General Smallwood Middle School  
HVAC and Roof Replacement  
CCPS Bid # GSMSHR1-2426

**Bid Addendum 01**  
February 15, 2024

11. SKETCH Drawings: AR101, AD101 and A105 Roof Replacement Clarification

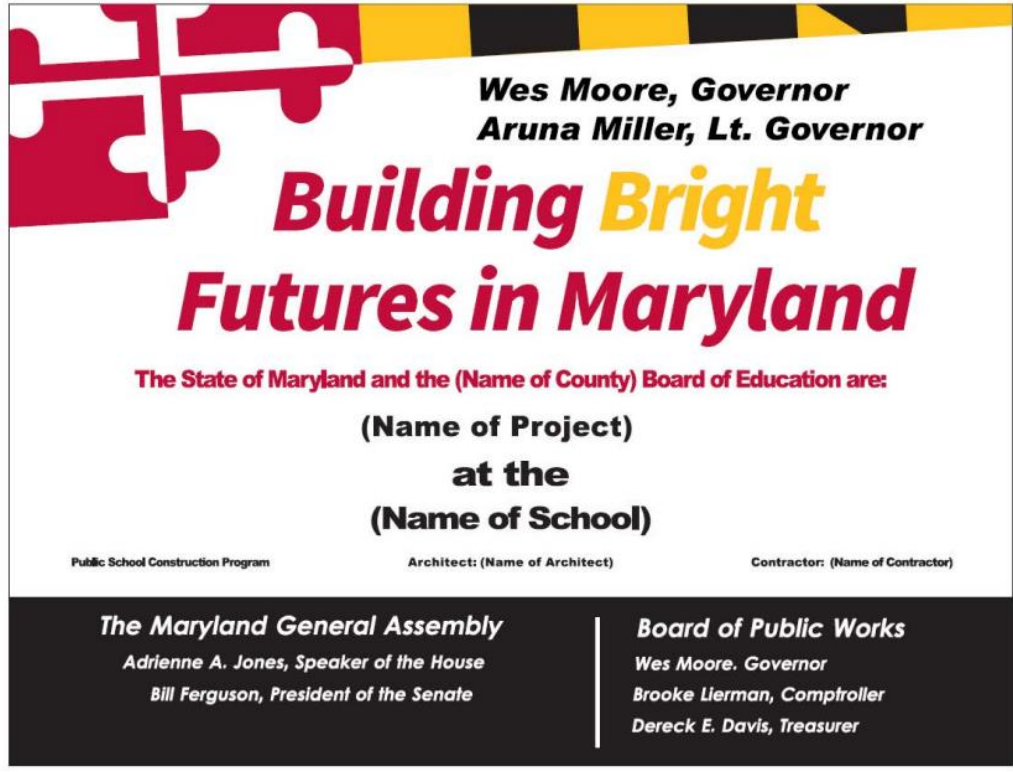
County Construction Sign shall be a nominal 96” x 48” on 5/8” MDF or Alkyd protected plywood. Adjust name of sign to coincide with the project title and to State standards as listed below. Verify with CCPS project manager.

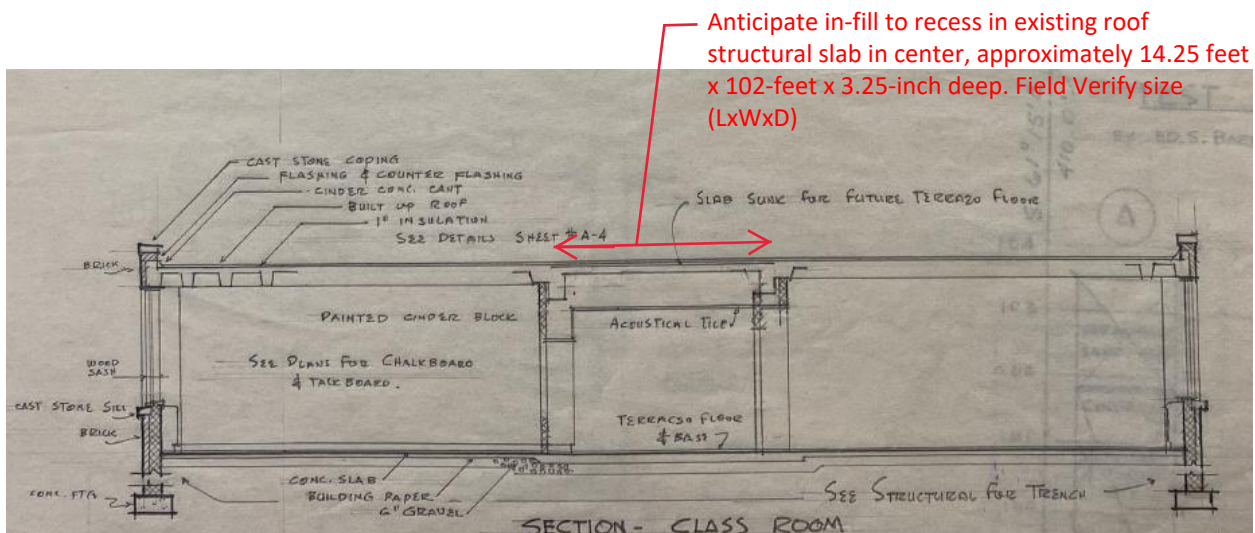
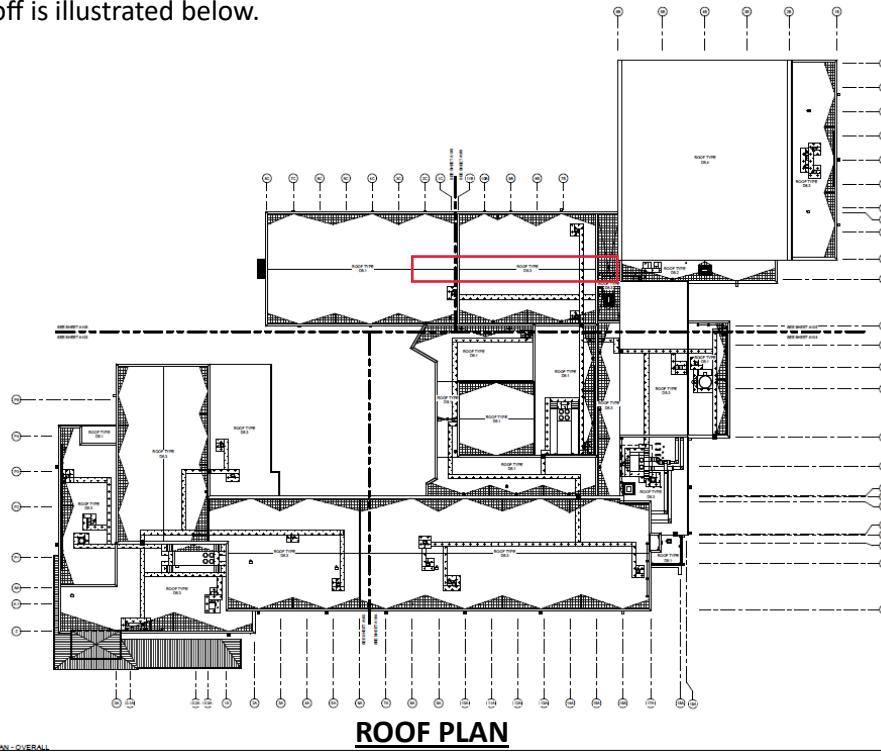
Amend the Roof Replacement scope of work to include the added demolition and roof fill as indicated on Sketch BA01-01 attached.

Amend Drawing pages AR101, AD101, and A105 to anticipate additional roof system tear-off and replacement to accommodate an original roof slab depression for future construction. Location of additional tear-off is illustrated below.
